**SUBJECT: EPA ID #NJD081982902
HSWA PERMIT
NOTIFICATION OF NEWLY IDENTIFIED AOC's**

Re: Chevron USA Products Company, a Division of Chevron USA, Inc. ("Chevron")
Perth Amboy, Middlesex County, New Jersey
EPA ID# NJD081982902
Full RCRA Facility Investigation (RFI) Report dated November 2003

The U.S. Environmental Protection Agency (EPA) Region 2 and the New Jersey Department of Environmental Protection (NJDEP) have reviewed the full RFI report cited above. Enclosed, is a letter from NJDEP, dated December 23, 2004, providing comments. Please respond to these comments by March 15, 2005.

LNAPL INVESTIGATION
AREA NF4
CHEVRON ASPHALT PERTH AMBOY

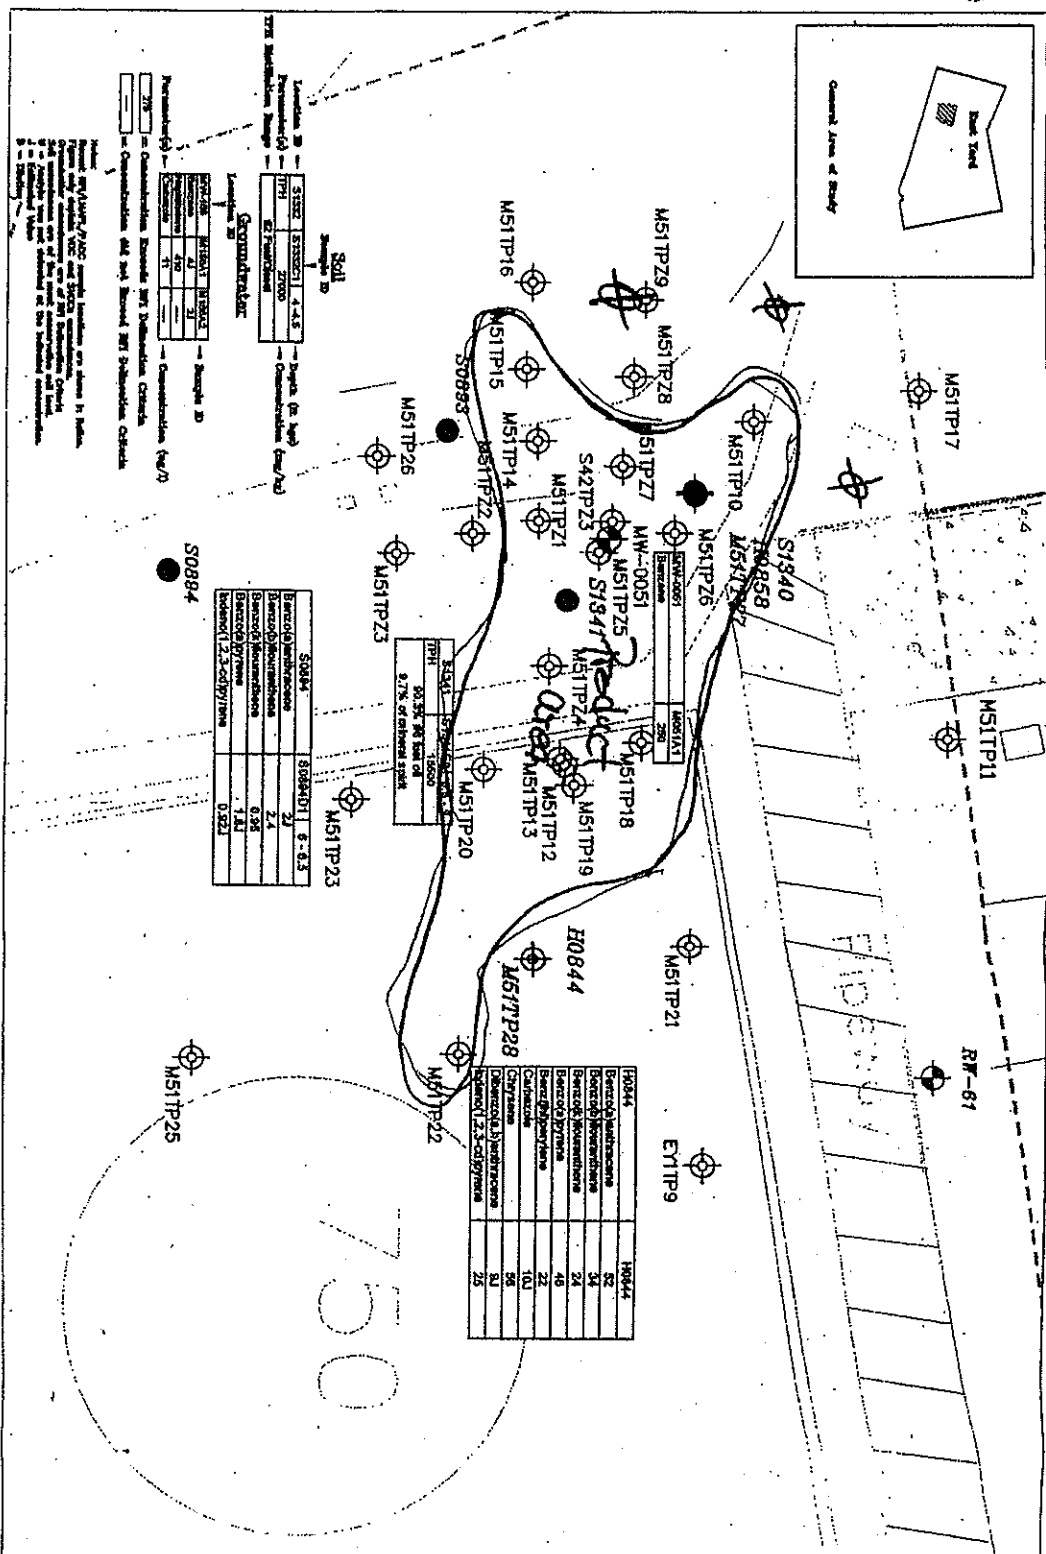
pg. 183, last #: Chevron indicates that ground water flow direction at area NF4 is northeast toward Woodbridge Creek. However, figure 8-10 shows a ground water depression between tanks 302, 328 and 330 and ground water flow in the area of tank 330 is toward that depression (toward the southeast). It may be that ground water flow in this area is controlled by subsurface utilities or by a downward vertical gradient in the area of NF-10. Chevron must determine the fate of ground water contamination in this area. Chevron shall install two additional monitoring wells between tank 330 and MW-0070 at the approximate locations indicated on attached, modified figure 7-9.

The source of the LNAPL in area NF4 is not identified. Chevron shall identify the source of the LNAPL at NF4. Chevron shall add this source to the HSWA permit as a SWMU/AOC. Chevron shall determine if the source is continuing to release contaminants to the environment.

LNAPL INVESTIGATION
SWMU 42

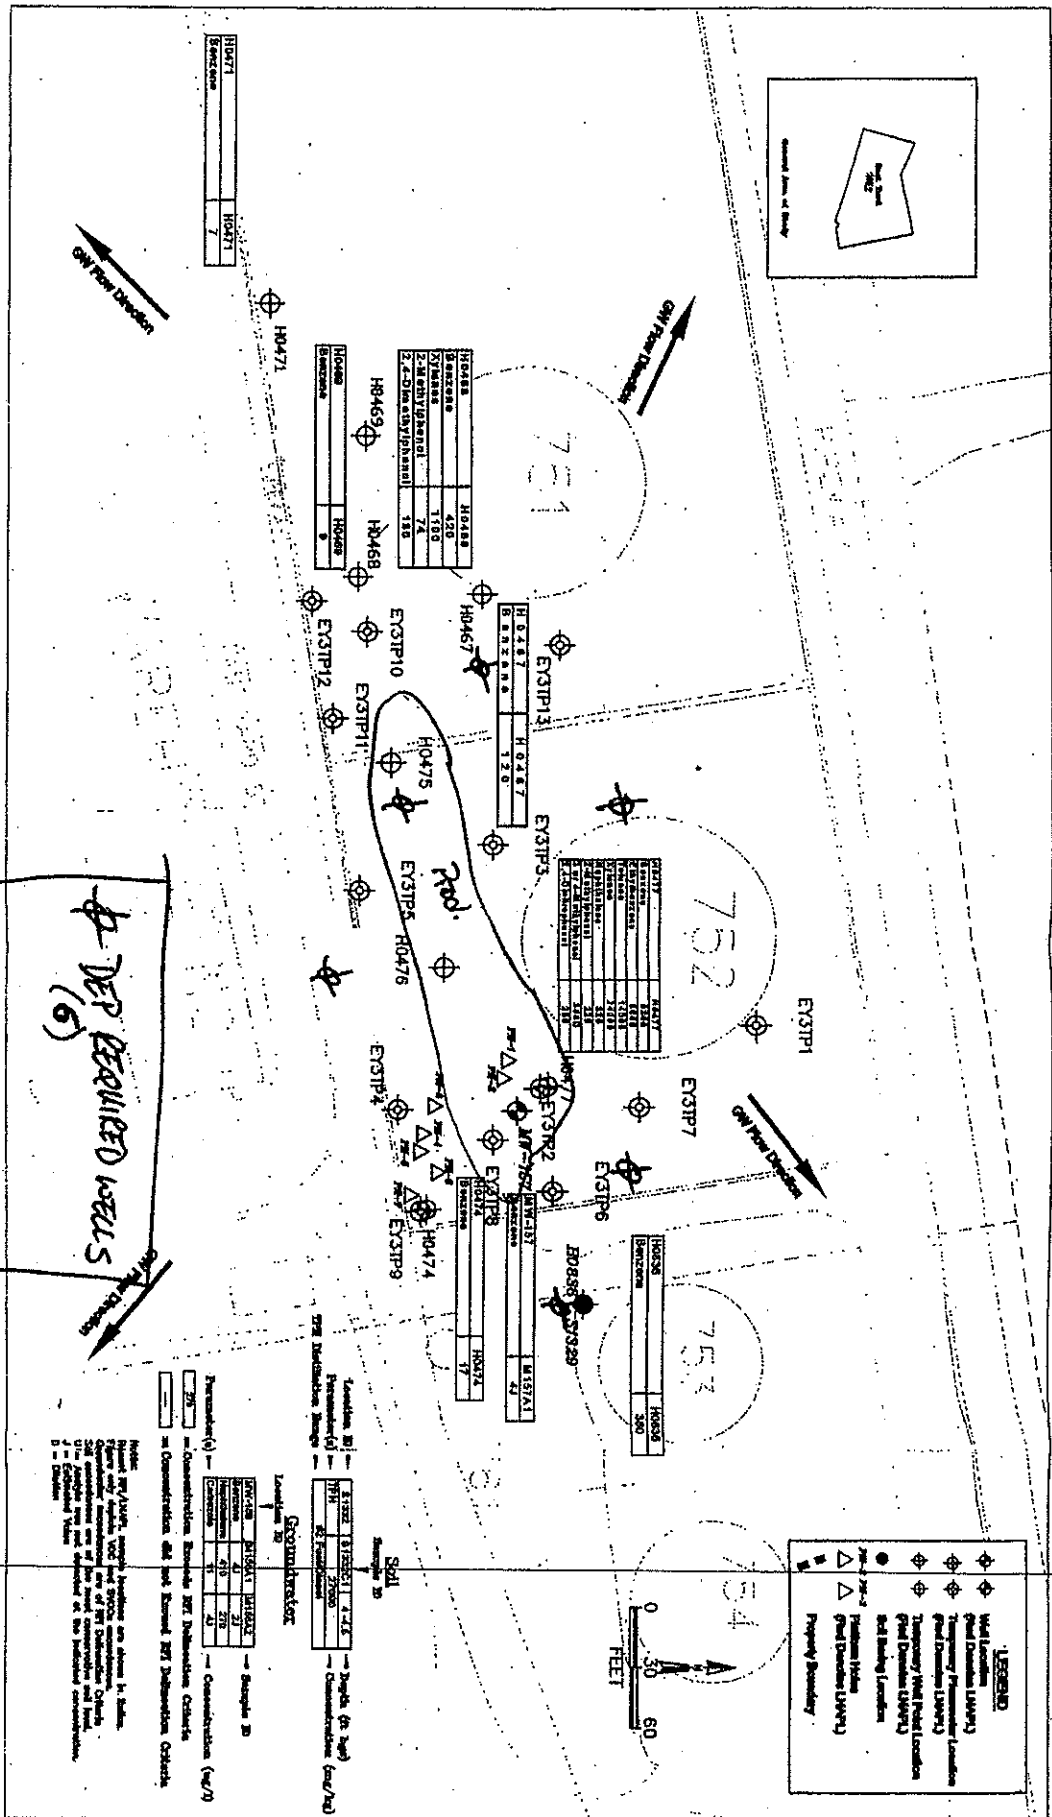
pg. 207, #3: Chevron shall install three permanent monitoring wells downgradient from the free product area to confirm local ground water flow direction and to monitor contaminant migration in the area. The wells shall be installed in the locations shown on attached modified figure 7-12 from the report and shall be constructed to screen the water table.

Figure 1 – Sylvan Map

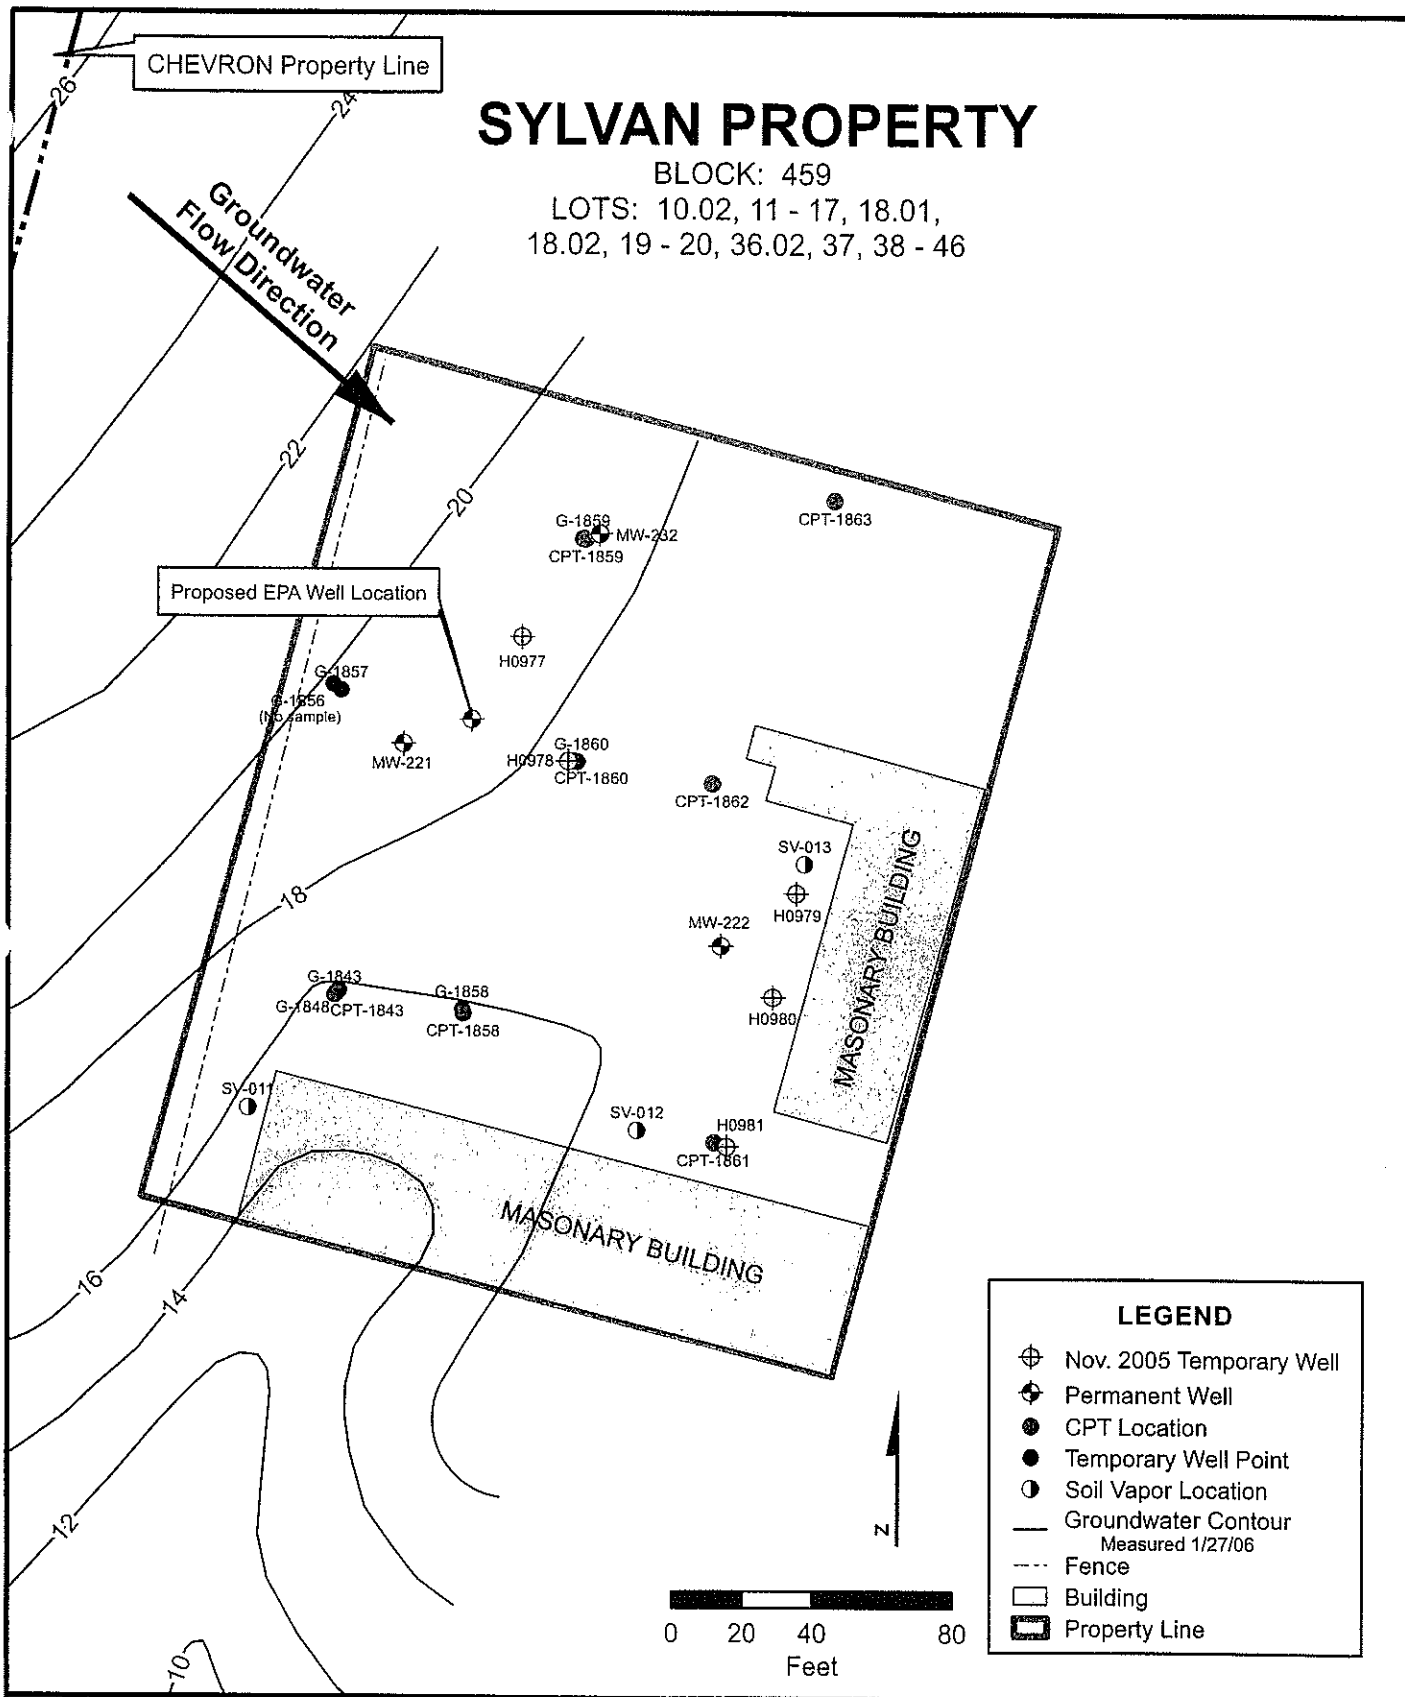
On November 18th, 2005, Chevron installed five temporary well points on the FM Sylvan, Inc. property in the same boreholes used for soil sampling locations H0977 through H0981 (See Figure 1). Temporary wells (1-inch outer diameter) were installed in each open borehole and screened (5 foot) across the targeted northern sand channel in the glacial till based on historical data and the boring logs for these locations. In each case, the bottom of each well screen was

Figure 2 - New Well Location Map

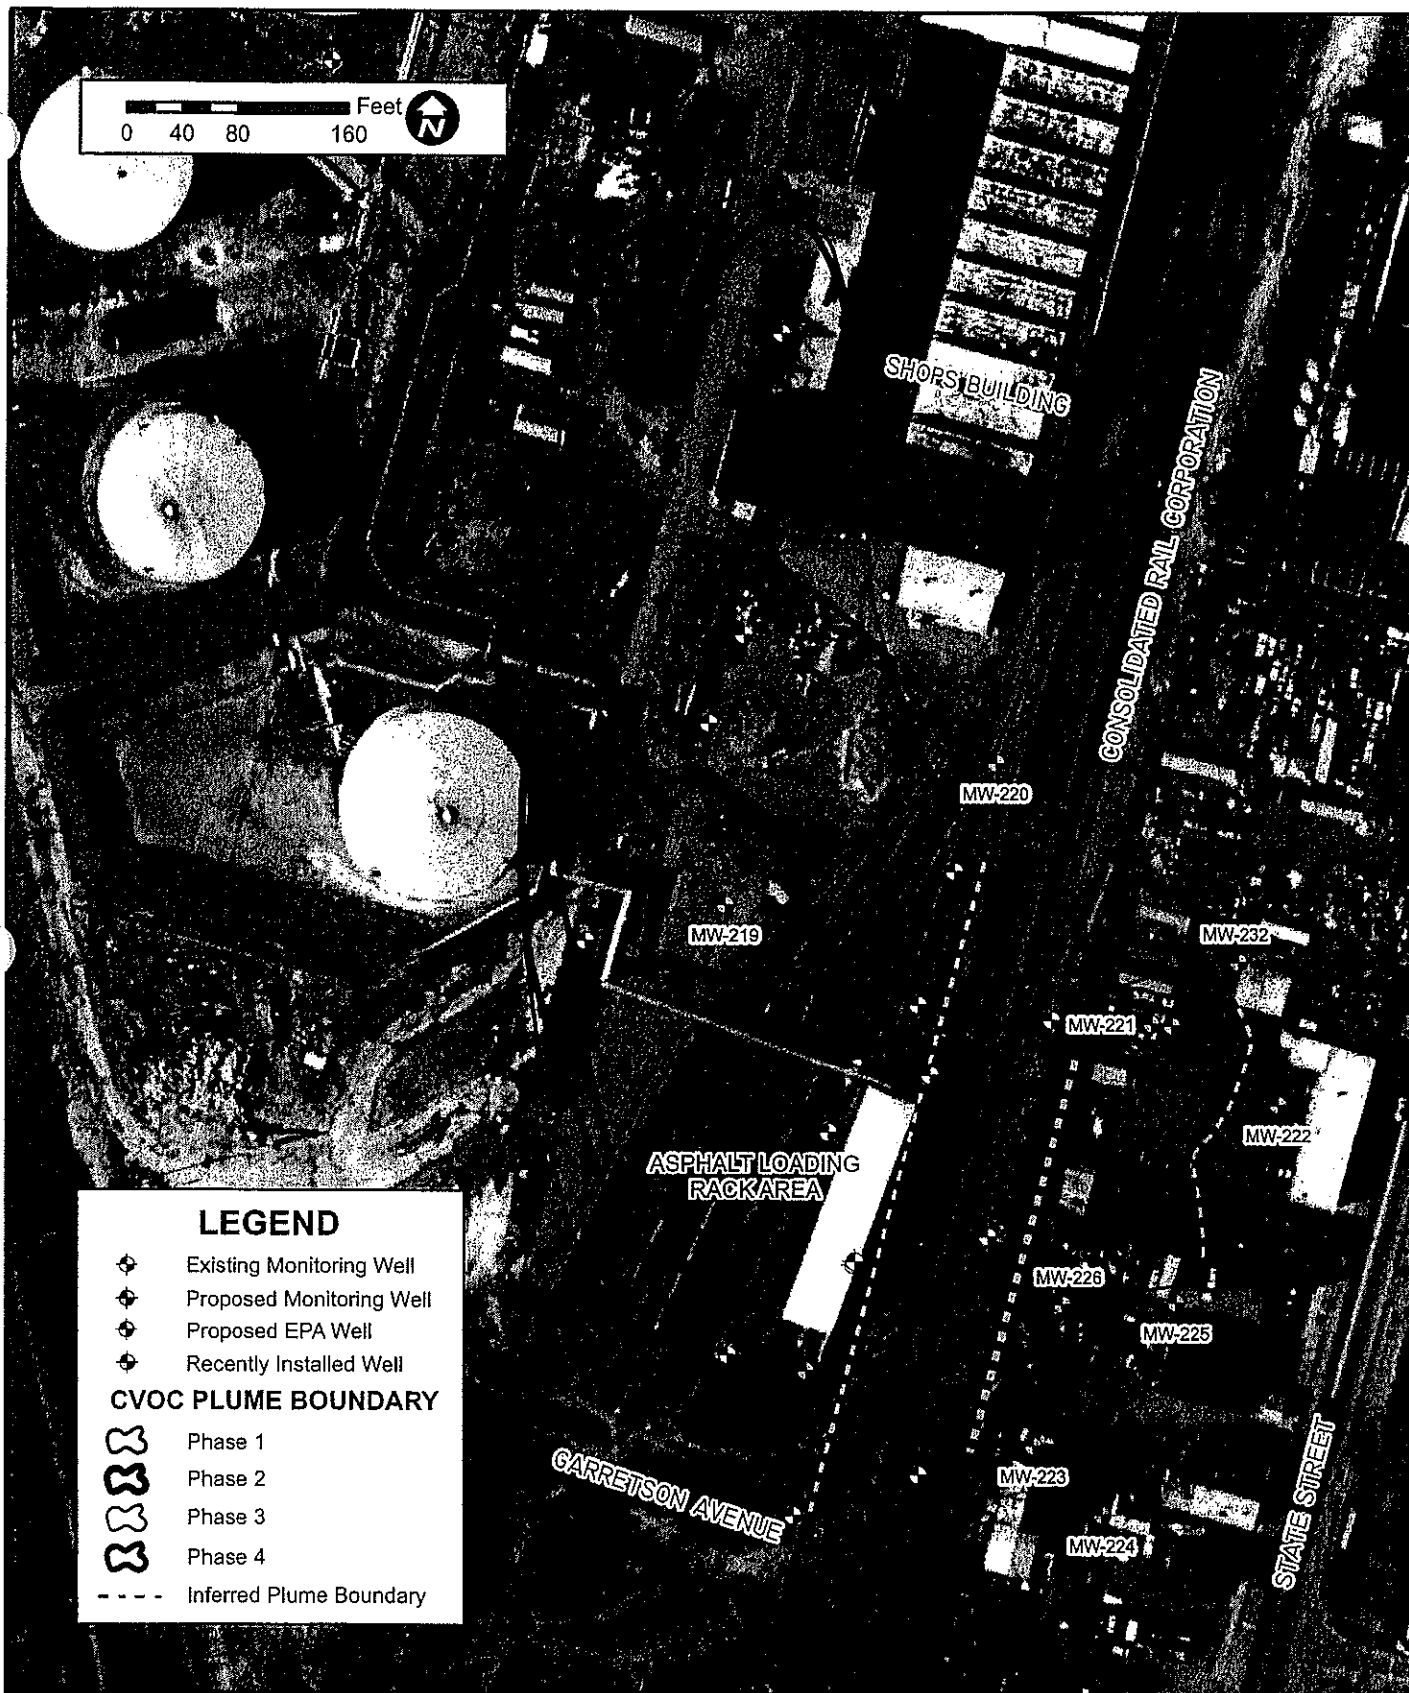
During the period of November 16th, 2005 and January 7th, 2006, Chevron installed eight shallow permanent groundwater monitoring wells as shown in Table 3 and on Figure 2.
